May 22, 2020

**RE: Point Ruston Development – Building 9/11A Site Plan Review (SDEV 19-0116)**

**RE: Point Ruston Development – FEIS Addendum Request for Comments (LU 19-0116)**

**RE: Point Ruston Development – FEIS Addendum 2<sup>nd</sup> Request for Comments (LU 19-0116)**

PROPOSED ARCHITECTURAL SITE PLAN - NOT APPROVED

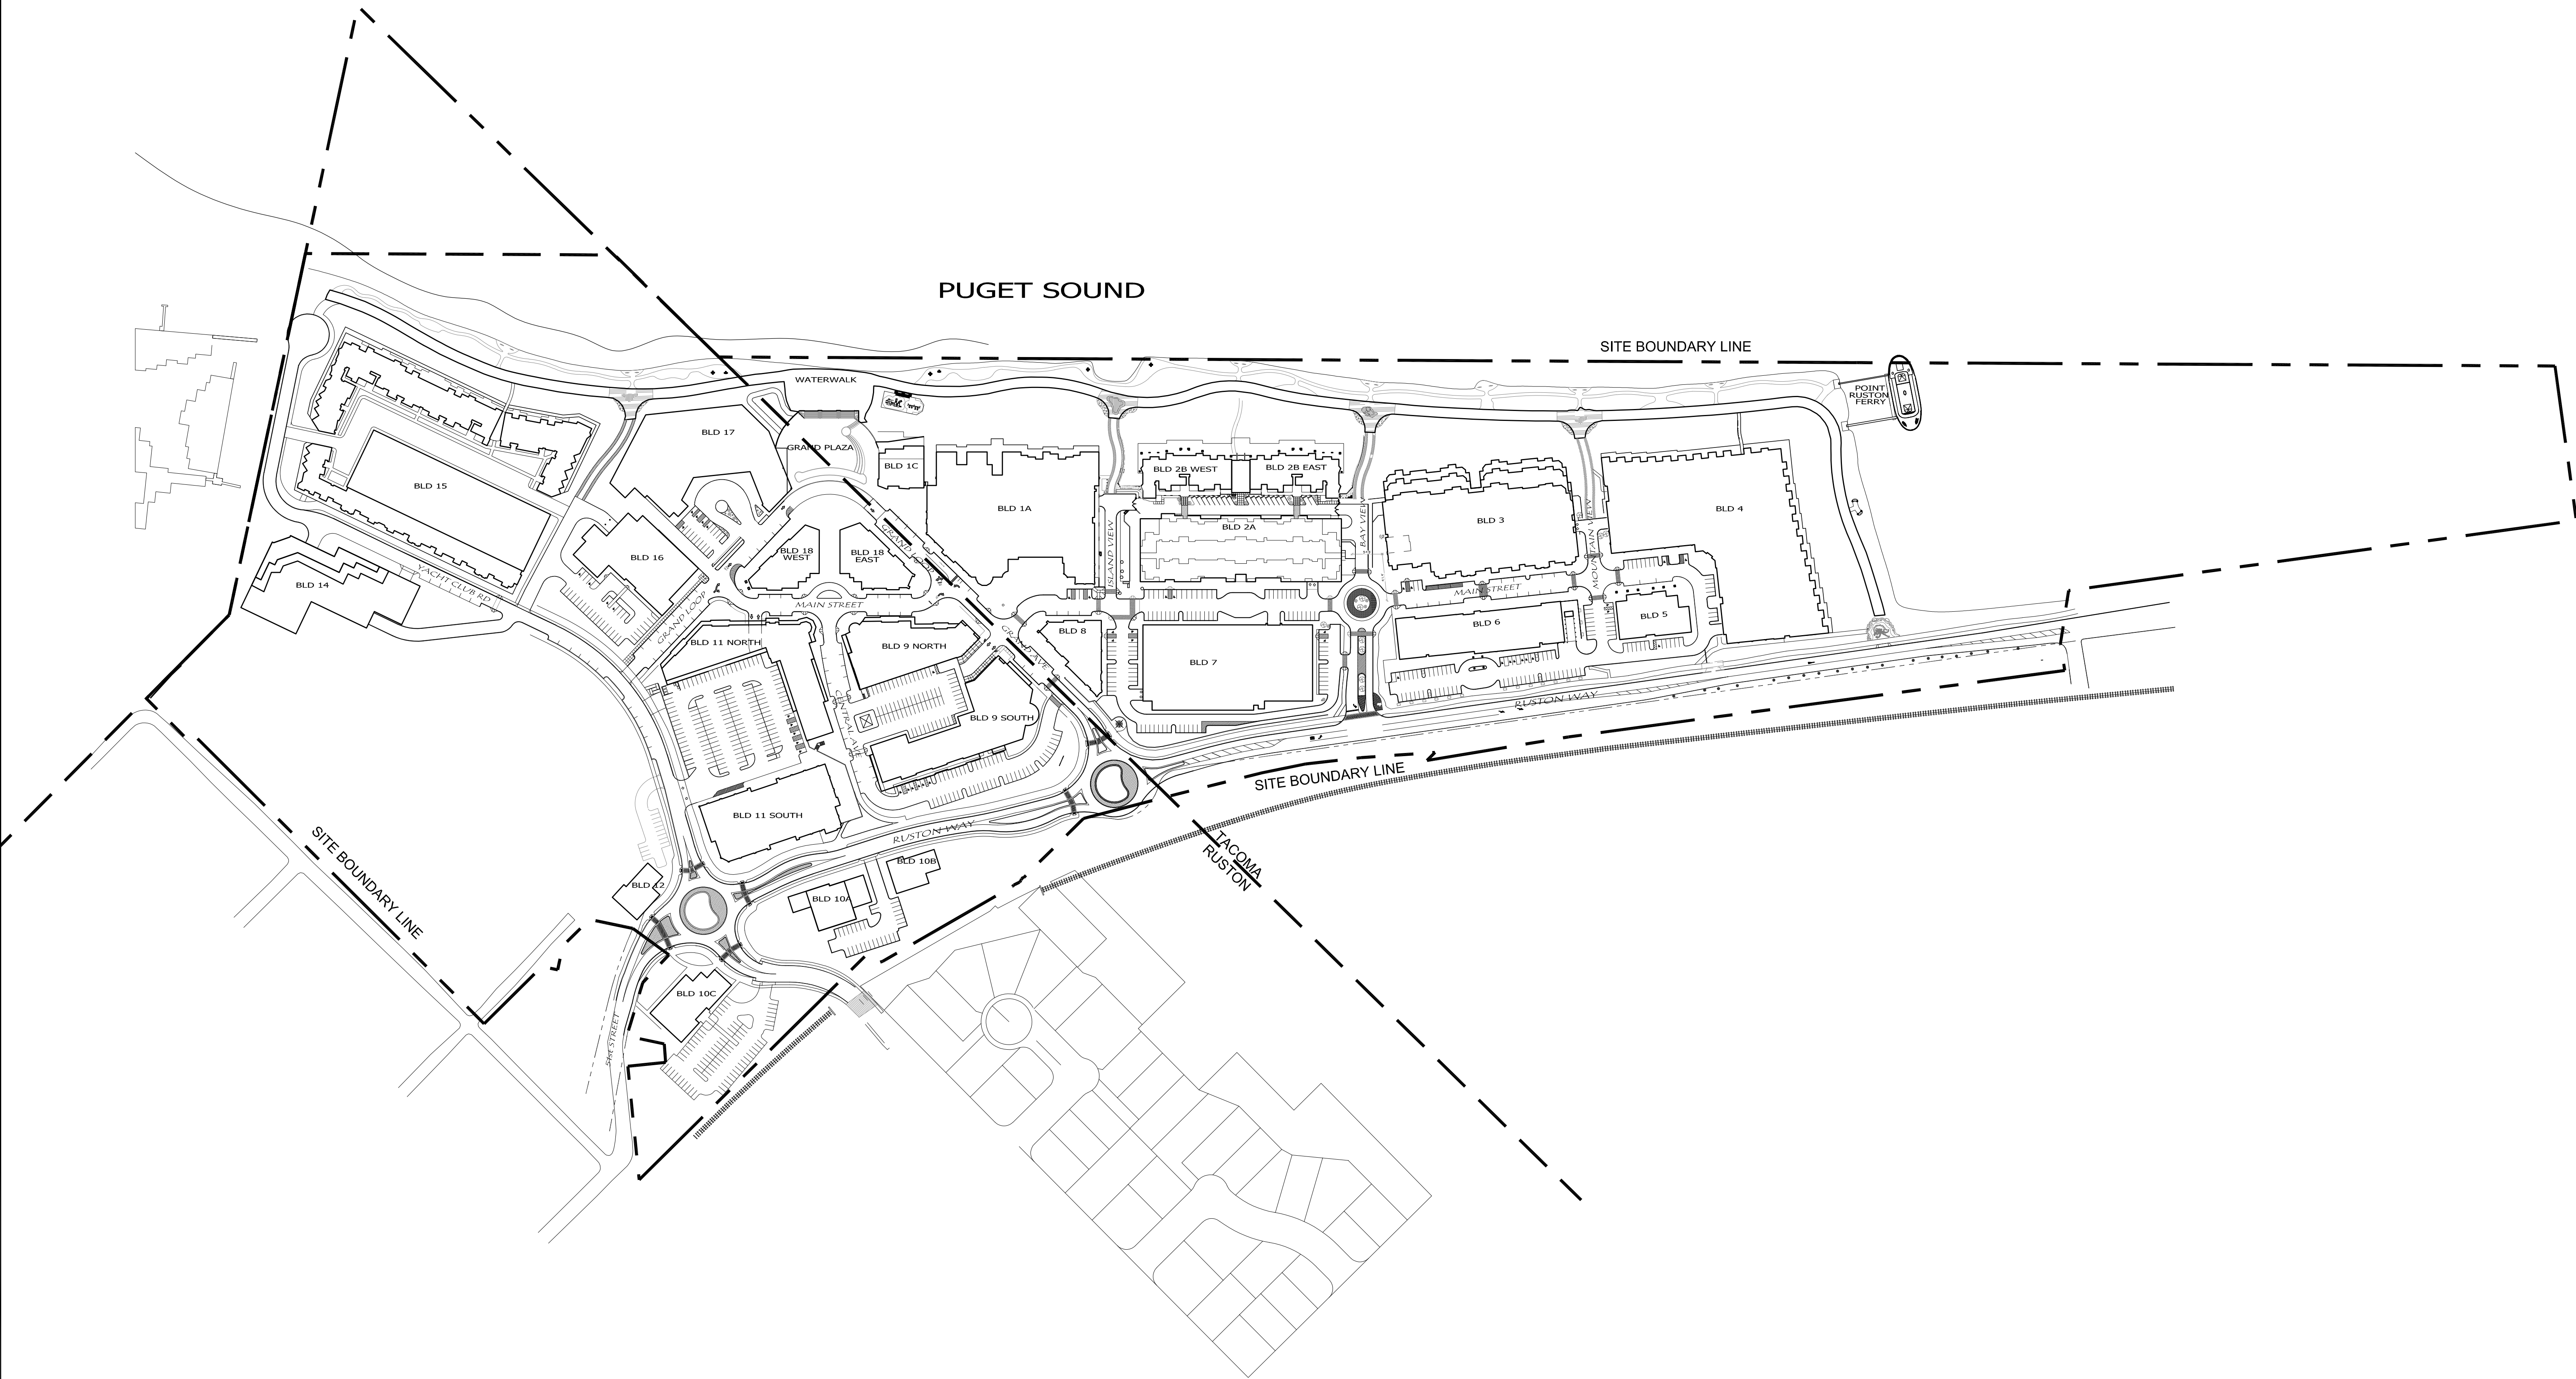
**1) Elimination of Cooling Pond Open Space/Addition of Building 10C and Surface Parking.**

The proposed plans indicate that the 75,000+ square foot open space and water feature, (commonly referred to as the “cooling pond”), is to be replaced with approximately 30,000 square feet of commercial space and an associated 76-stall surface parking lot, identified as Building 10C.

**2) Elimination of Building 9 Open Space (Wellness Center Plaza)/Conversion to Surface Parking Lot.**

The proposed plans indicate that the Wellness Center Plaza open space and continuous commercial frontage along Central Avenue and above Building 9 are to be replaced with a surface parking lot at roof level P3 of the parking garage. This proposed modification to the site plan eliminates required open space and significantly impacts the urban design quality of Central Avenue, which is classified as a pedestrian-oriented street by RMC 25.06.050(a) because it serves as the primary pedestrian link between the waterfront and thousands of surrounding Ruston and North Tacoma residents as they traverse the Point Ruston site through Market Plaza, Central Avenue, Central Plaza, Main Street and Grand Plaza to the water.

**3) Elimination of Pedestrian Connectivity.**

The proposed plans indicate that multiple pedestrian connectivity routes and street crossings linking Ruston Way, Building 11B, Central Avenue, Main Street, Grand Avenue, Market Plaza, Wellness Center Plaza, and between Buildings 9A/B/C are to be eliminated.

Because the application proposes to decrease the quality and quantity of required open space; reduces pedestrian connectivity; and results in a decrease in overall urban design quality, a **major** amendment to the Point Ruston Master Development Plan is required, prior to site plan approval. Major amendments are considered a quasi-judicial decision and are processed in accordance with RMC Title 19, which requires that a public hearing be held before the Ruston Hearing Examiner.

# Attachment A - City of Ruston/Point Ruston FEIS Addendum Comments, November 22, 2019

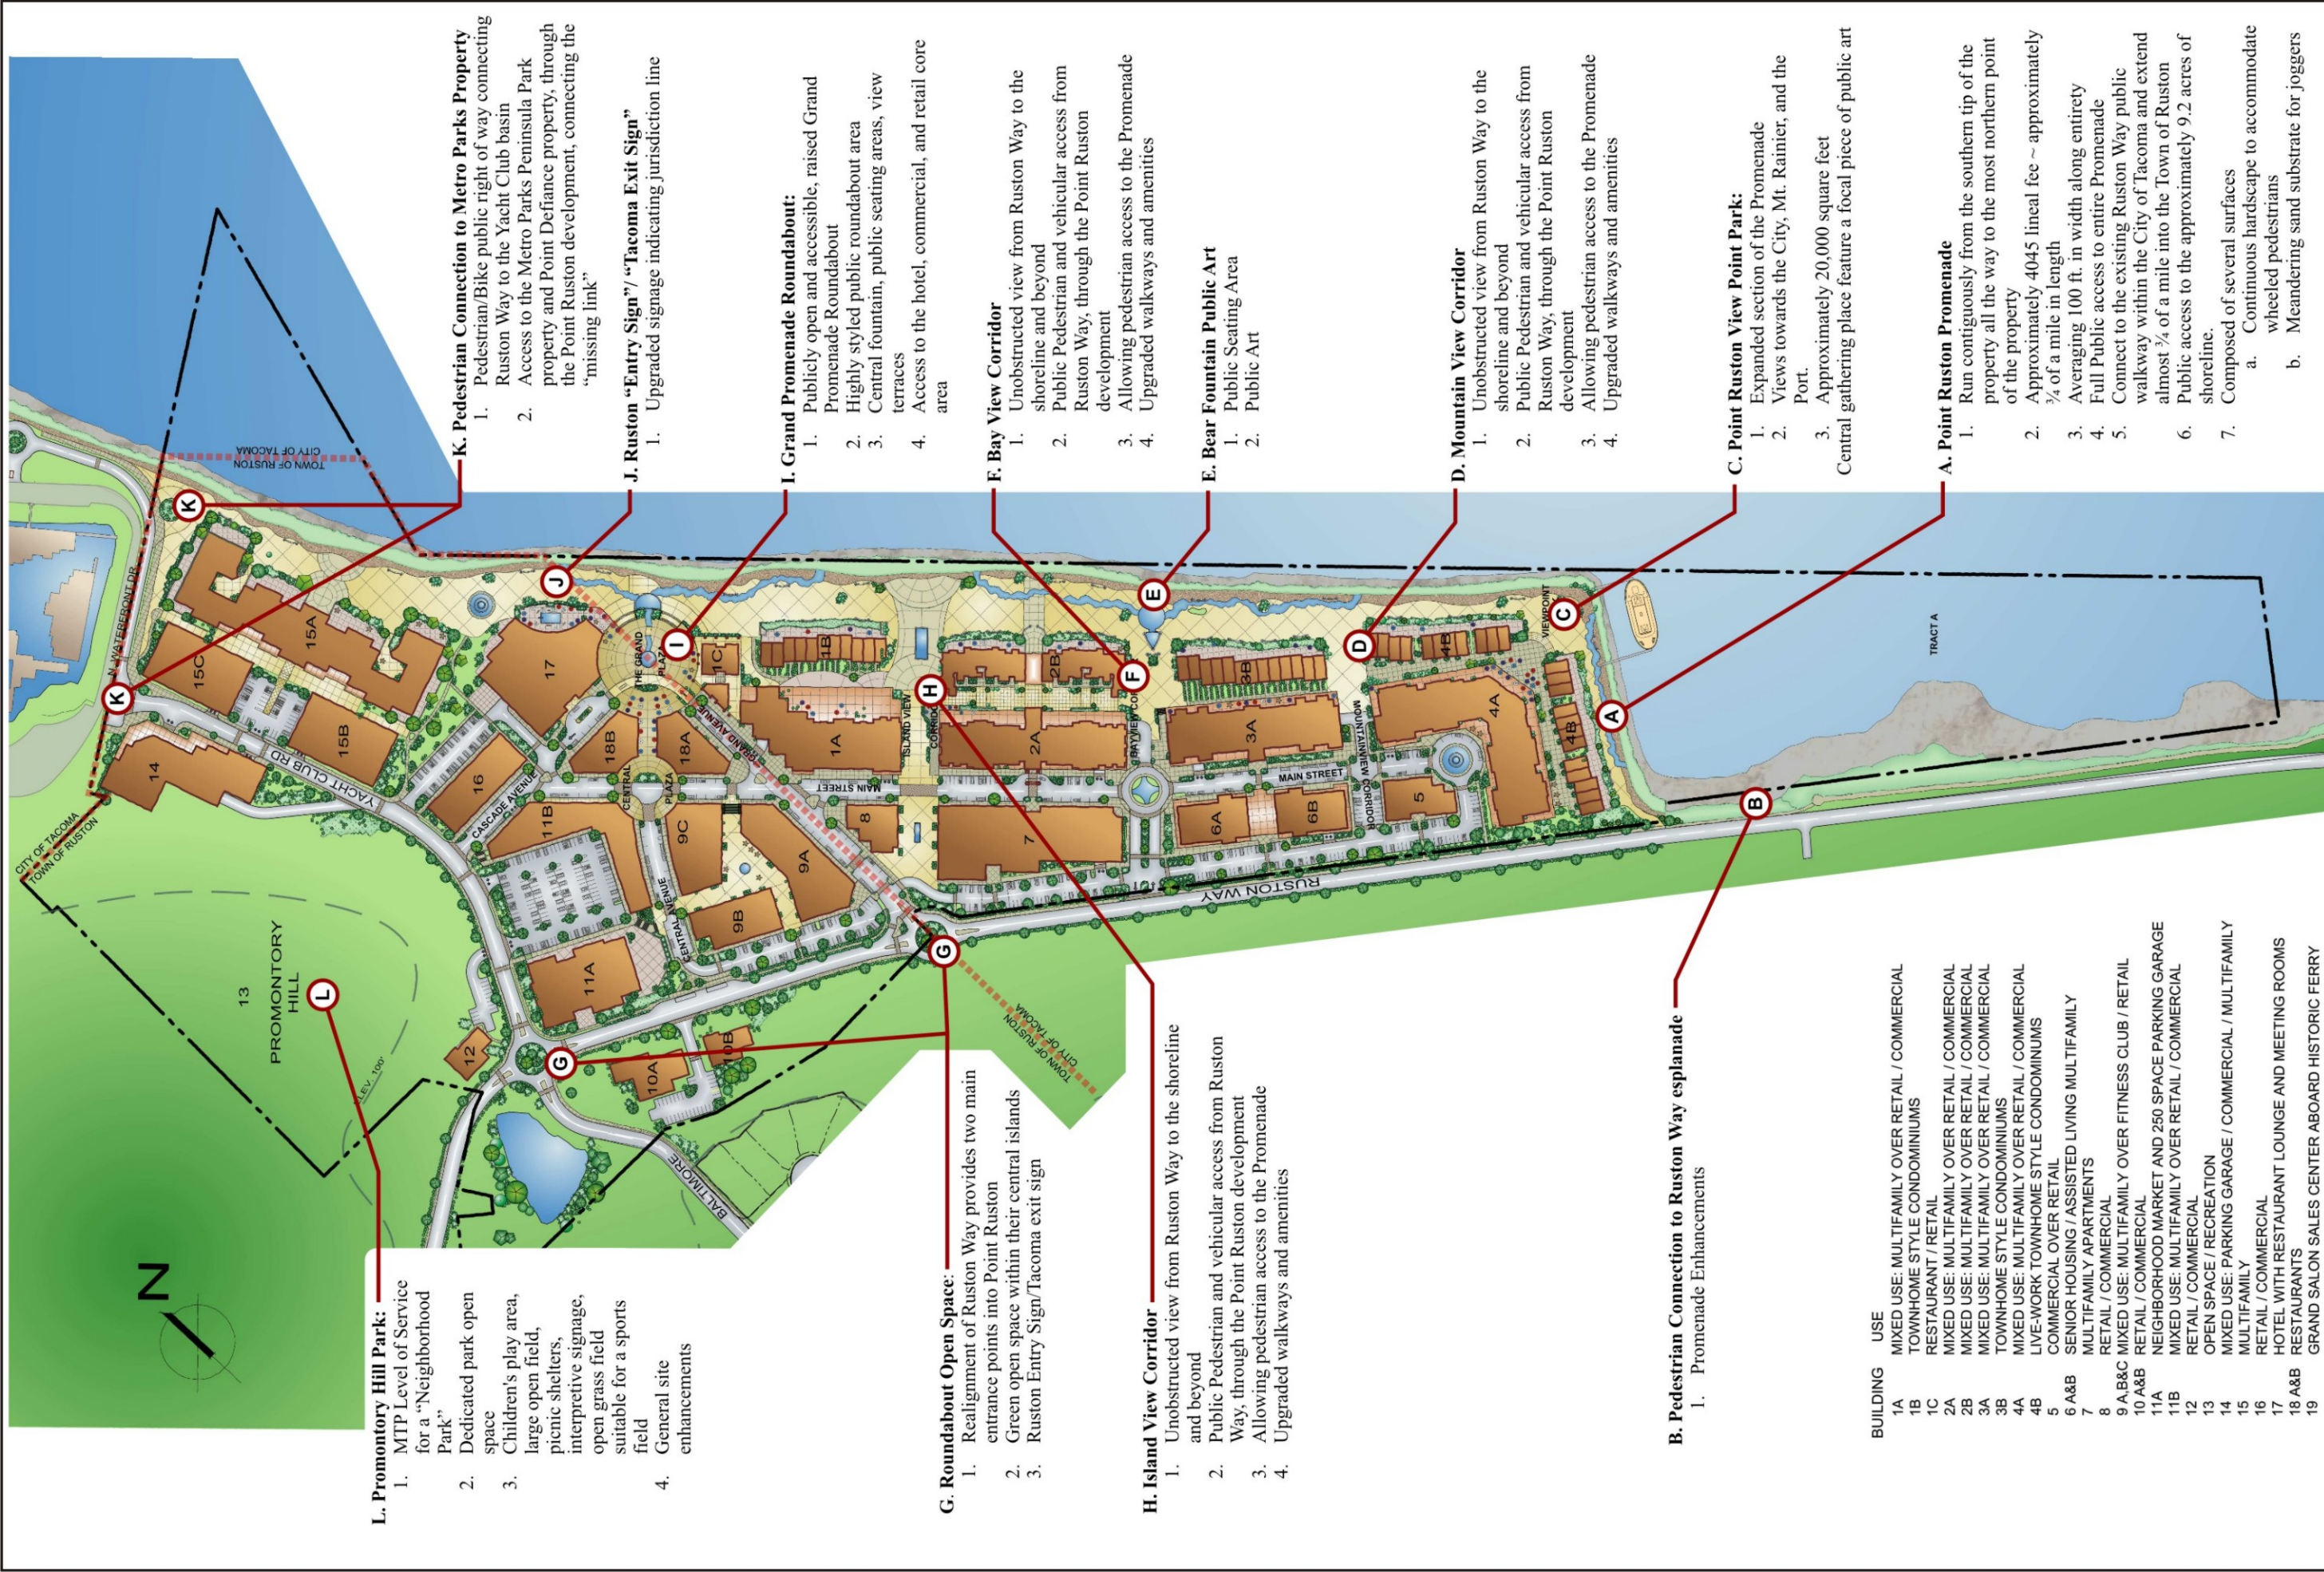
Additionally, we recommend that the following mitigation items (which are shown in more detail on **Attachment A – City of Ruston/Point Ruston FEIS Addendum**), be incorporated into the project requirements as combined potential mitigation items to address both multi-modal traffic and open space impacts:

- a. **Waterwalk/Promenade Capacity.** The width of the hard-surface Waterwalk/Promenade path as constructed is not consistent with the width depicted on the FEIS site plan, PRMDP site plan, or Silver Cloud Hotel Shoreline Substantial Development Permit site plan. The revised multi-modal TIA requested above should also consider impacts to the capacity of this transportation route and provide for mitigating measures to increase its width and capacity. More specifically, improvements should be made to separate bicycle/scooter traffic from pedestrian traffic through a combination of lane striping, surface textures, curbing, signage and/or other alternate methods.

- b. **Promontory Hill Park Design and Construction Schedule.** The existing FEIS requires Promontory Hill Park to be designed to Metro Parks Tacoma (MPT) standards for a “Neighborhood Park”, which is dedicated to the public as permanent open space (via easement preferred), and includes a children’s play area, large open fields suitable as a sports field, picnic shelters, interpretive signage, and other general site enhancements. According to MPT standards, adequate parking would also be required, which would be most appropriately located along the Bennett Street frontage from N 53<sup>rd</sup> to N 54<sup>th</sup> as parallel on-street parking. The City of Ruston requests that the design and conveyance of an

- d. **52nd Street Pedestrian Connection and Alley.** A pedestrian and vehicle access facility connecting upper Ruston and north Tacoma residential neighborhoods to the Point Ruston site along the south side of Promontory Hill Park, behind Building 12 to a crossing at Yacht Club Road and the Ruston Market should be constructed by Point Ruston as mitigation. The alley/walkway should be available for pedestrians and also for utility/vehicle access to the rear of buildings fronting on 51<sup>st</sup> Street, including Building 12. This mitigation item must be completed prior to occupancy of Building 12.

- e. **Ruston Loop Trail Connection through Buildings 10A/B to Central Avenue.** This pedestrian connection from the future Ruston Loop Trail at Rust Park, through Buildings 10A and 10B, with a mid-block crossing at Ruston Way and Central Ave should be required as mitigation to partially address the impacts created by the expanded density and project scope. The addendum should clarify that this improvement needs to be completed prior to occupancy of either Building 10A or 10B.
